Commonwealth Edison

February 18, 1983

Subject: Quad Cities Station Units 1 and 2
Transmittal of Supplement 9 of
Revision 1 to the Licensing Report
on High Density Fuel Racks
NRC Docket Nos. 50-254 and 50-265

Enclosed is Supplement 9 to Revision 1 of the report prepared by Joseph Oat Corporation for Commonwealth Edison entitled "Licensing Report on High Density Spent Fuel Racks for Quad Cities Units 1 and 2."

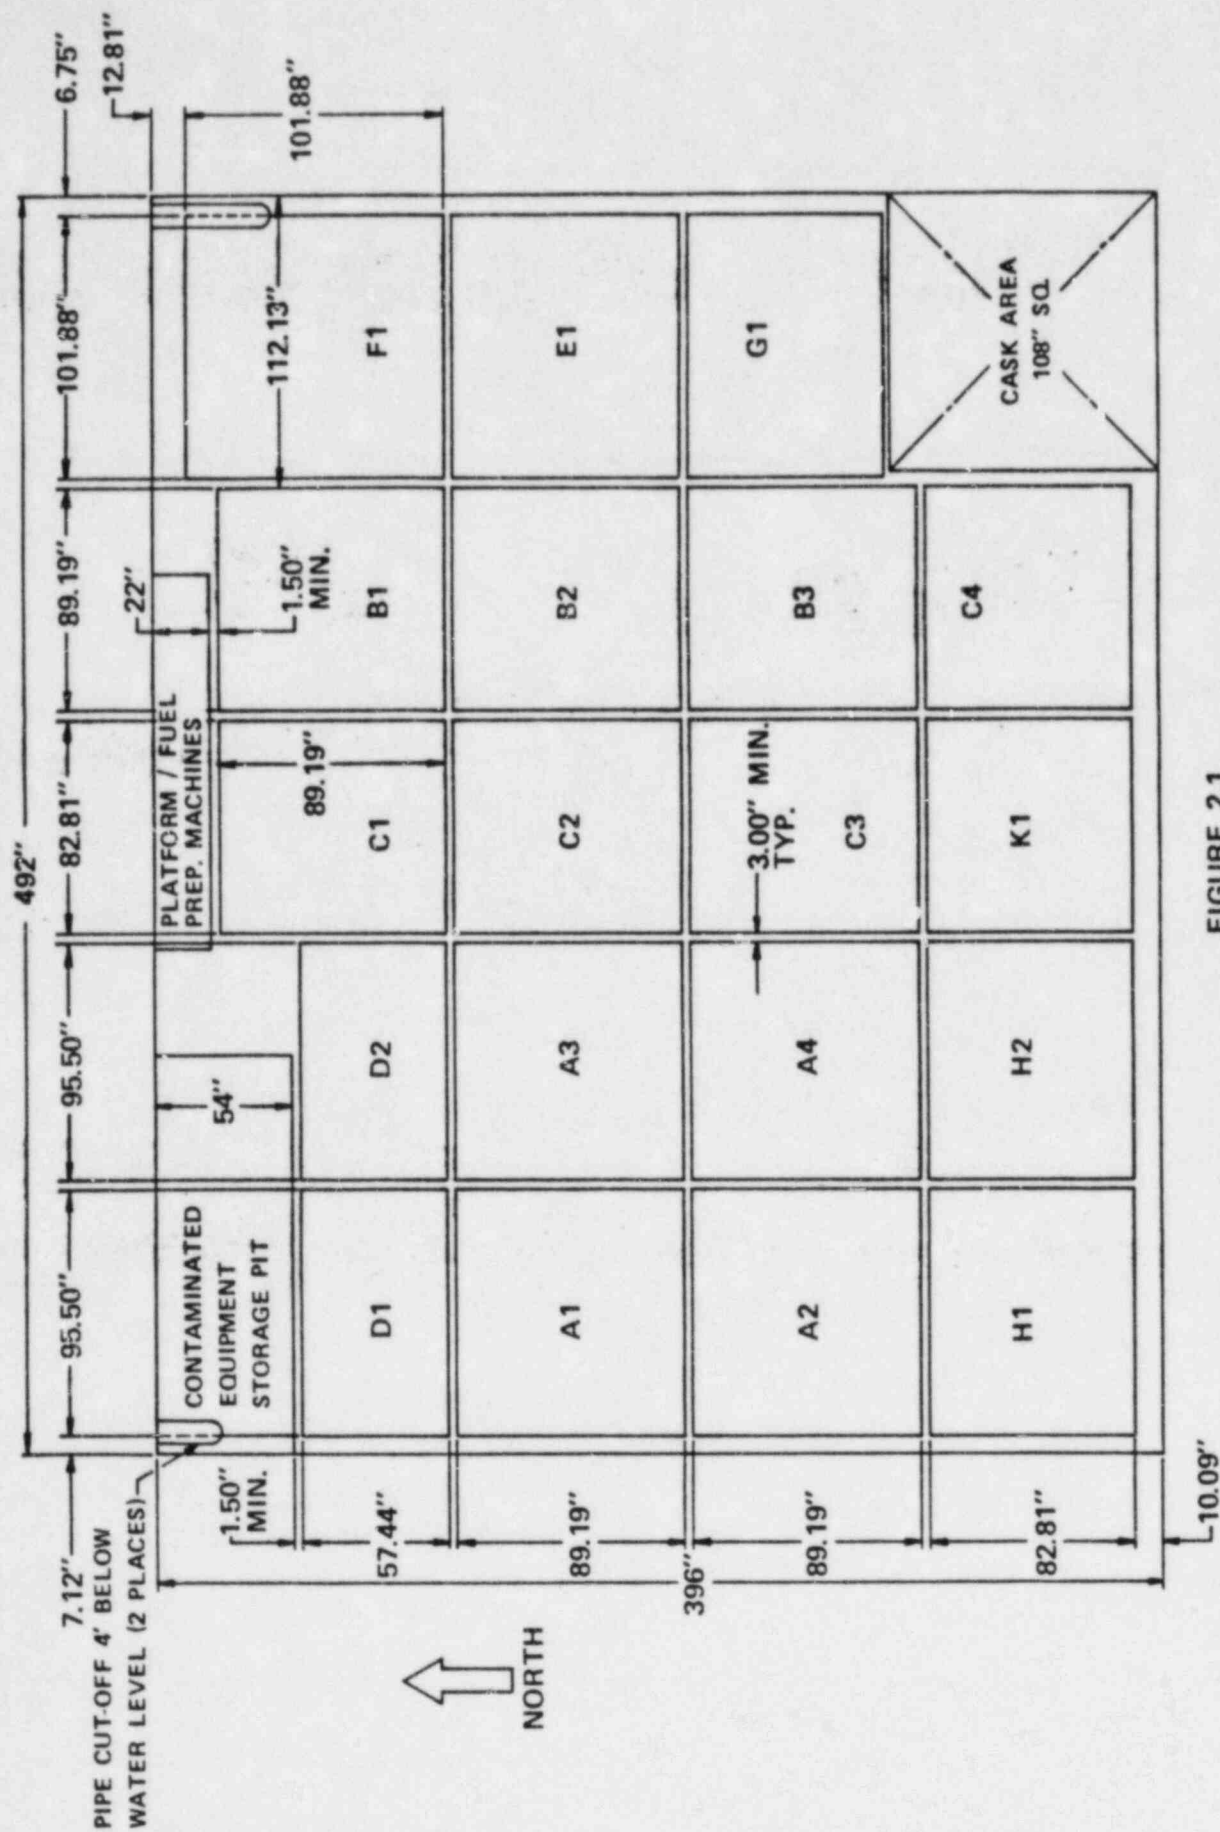
The primary changes are the reduction in the number of storage cells to be installed and the related effect on the thermal and radiological analysis and revision to the minimum spacing between rack modules, the fuel pool wall and fuel pool wall fixtures. The revised spacing arrangement is consistent with our seismic and thermal-hydraulic analyses approved by the NRC. Additionally, minor corrections were incorporated. The following corrected sheets are attached: Pages 1-3, 2-1, 2-2, 2-3, 3-4, 3-5, 5-4, 5-11, 8-2, 10-2, 11-5, 11-6, Table 1.1, Figure 2.1, Figure 2.2, and Figure 3-7.

The Quad Cities Unit 1 pool will contain 19 high-density fuel racks in 9 different module sizes. The module types are labelled A through K in Figure 2.1, which also shows their relative placement. There will be a total of 3657 storage locations in the Quad Cities Unit 1 pool. 9

FIGURE 2.2
GENERAL ARRANGEMENT OF RACK MODULES FOR QUAD CITIES UNIT 2
(3897 CELLS)

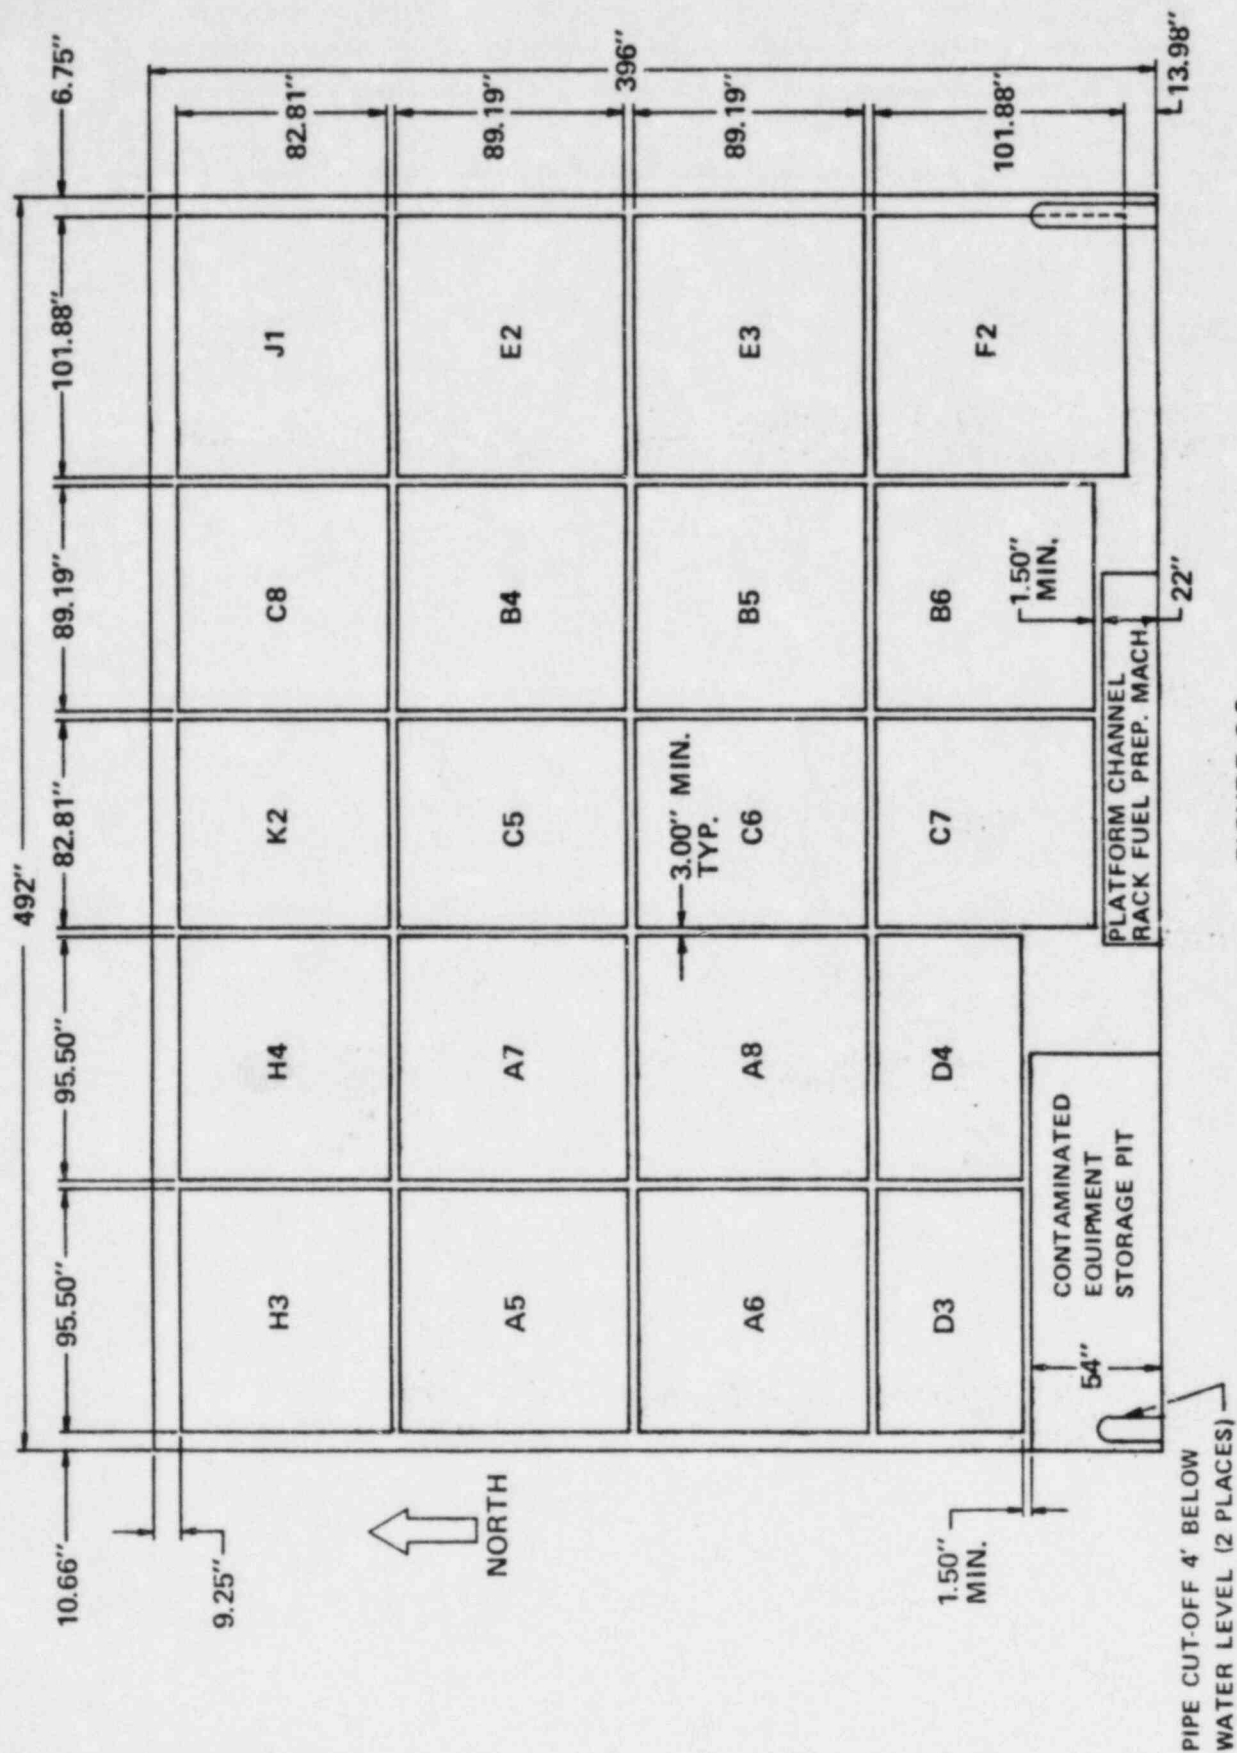
The Quad Cities Unit 2 pool will contain 20 high-density fuel racks in 9 different module sizes. The module types are labelled A through K in Figure 2.2, which also shows their relative placement. There will be a total of 3897 storage locations in the Quad Cities Unit 2 pool. 9
